GGG–B–101d
AMENDMENT–3
February 17, 1965
SUPERSEDING
Interim Amendment–2
May 7, 1964 and
Amendment–1
January 2, 1964

FEDERAL SPECIFICATION

BARS; CHISEL, PINCH, PRY, WRECKING, DIGGING, TAMPING, DIGGING AND TAMPING; AND CROWBARS

FIGURE 6. *Type V, class 1, style A wrecking bar, gooseneck, with claw, and pinch point.*

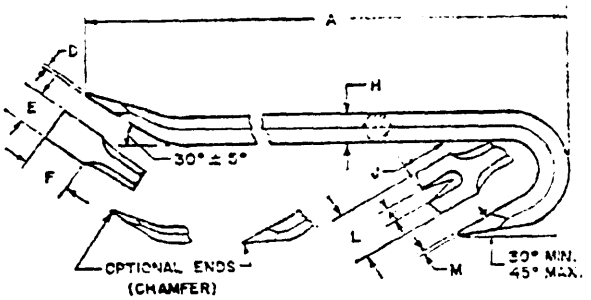
Page 5, figure 6. Delete and substitute:
